PLANNING COMMISSION STAFF REPORT CRESTVIEW CROSSING PLANNED UNIT DEVELOPMENT AND CONDITIONAL USE PERMIT

HEARING DATE: October 11, 2018

FILE NO: PUD18-0001/CUP18-0004

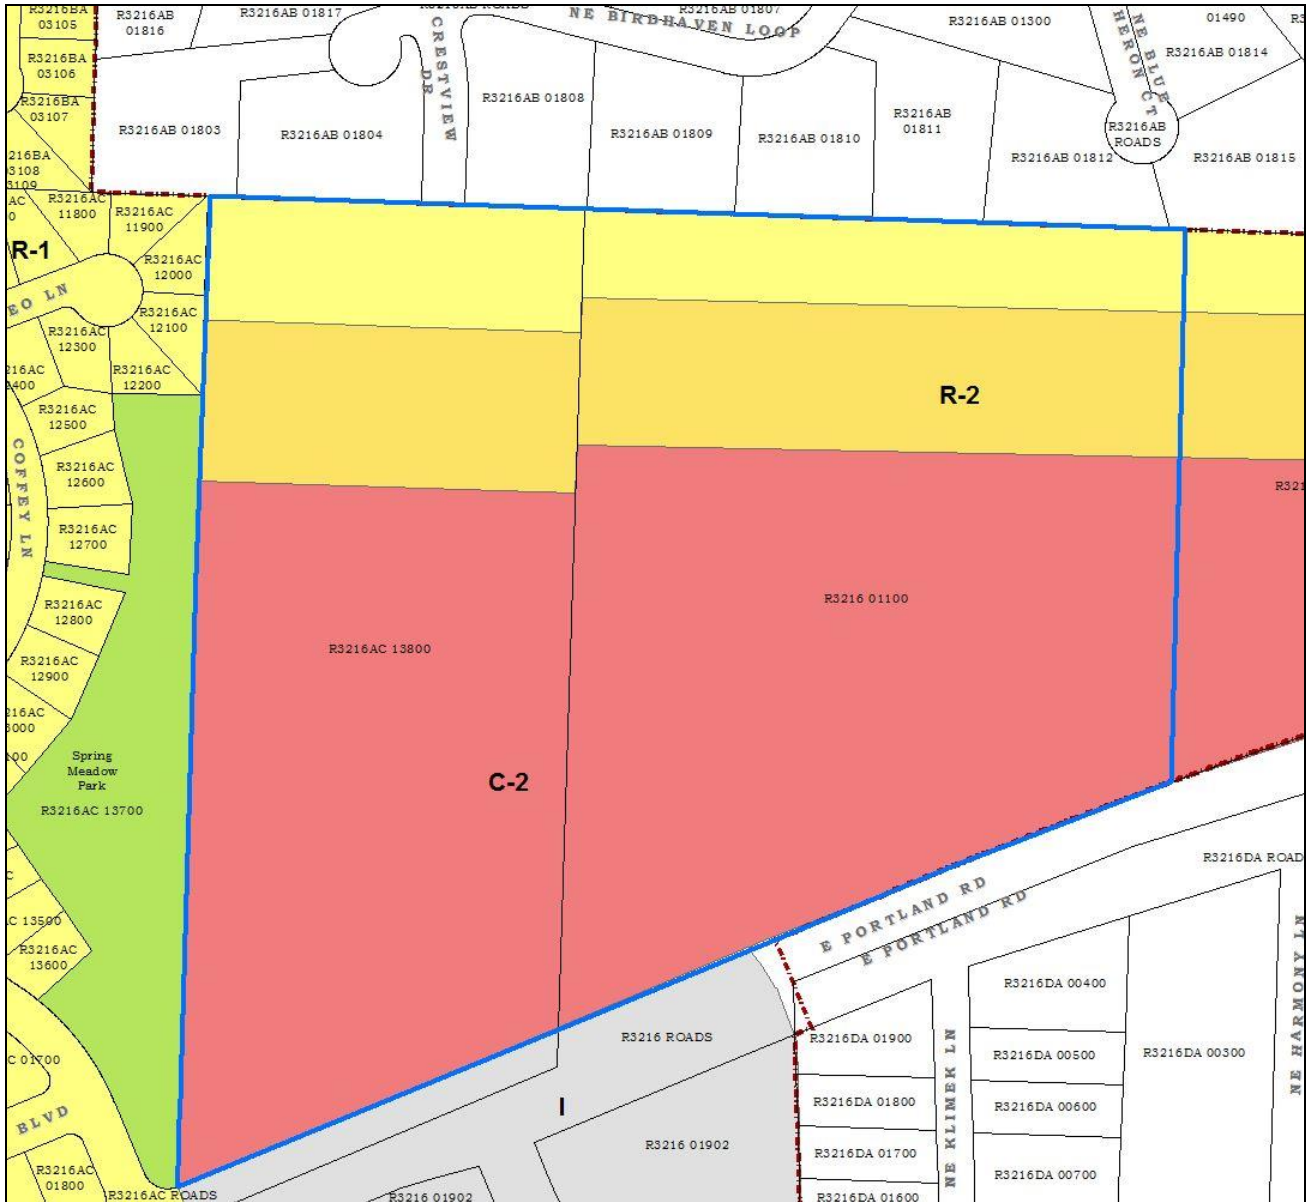
City staff do not concur with the proposed condition of approval as jointly drafted by the applicant and Oxberg Lakes Estates HOA. City staff proposed the following modified condition of approval to address the entire northern property line of tax lots 13800 and 1100. The Applicant shall construct and install the Sound Wall in such a manner as to preserve, to the best of Applicant's ability, those trees with trunks greater than twelve (12) inches DBH that are located near the south boundary of tax lots 1803, 1804, 1808, 1809, 1810, 1811, 1812 and a westerly portion of tax lot 1815.

“The Applicant shall provide the owners of tax lots 1803, 1804 and 1808 with copies of any proposed designs and drawings of the Sound Wall, and consider, in good faith, all timely comments Applicant receives from the owners with respect to the Sound Wall. However, the final design and specifications of the Sound Wall shall be in accordance with plans approved by the City of Newberg, or any other governmental agency having jurisdiction. Applicant shall complete the construction and installation of the Sound Wall on or before the date of final lift of asphalt concrete within the Applicant's development. The owners shall grant the Applicant a temporary construction easement for the sound wall.”

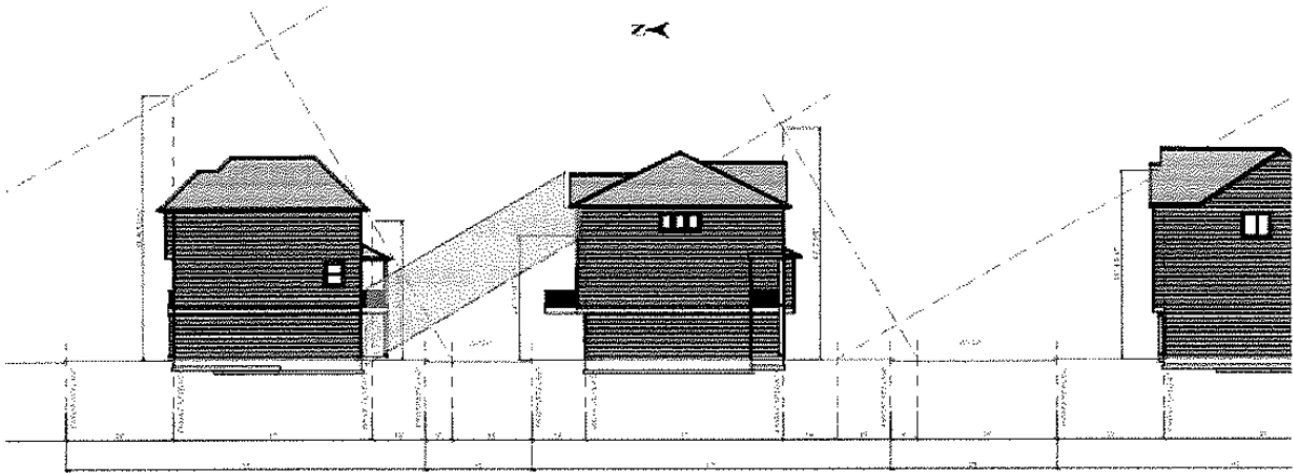
The lot coverage listed above is from the NDC and was current at the time the applicant made their submittal. The applicants’ narrative and sheet C150 listed different requested maximum lot coverages. The PUD process allows for adjustments to the strict adherence to requirements listed in

The current NDC does not have a maximum lot coverage for C-2 zoned property. The applicant is proposing a number of residential lots within the C-2, which allows for residential land use with a conditional use permit.

In summary, the applicant is requesting a 10% increase in combined lot and parking coverage over the current maximum of 60% combined lot coverage allowed for in the R-2 zone.

Because there are no adverse impacts anticipated to units within the proposed development and to existing surrounding properties, it is appropriate to allow an increase of a combined lot and parking coverage of 70% within the R-2 zone. This criterion along with section 15.240.020.I. have been met.
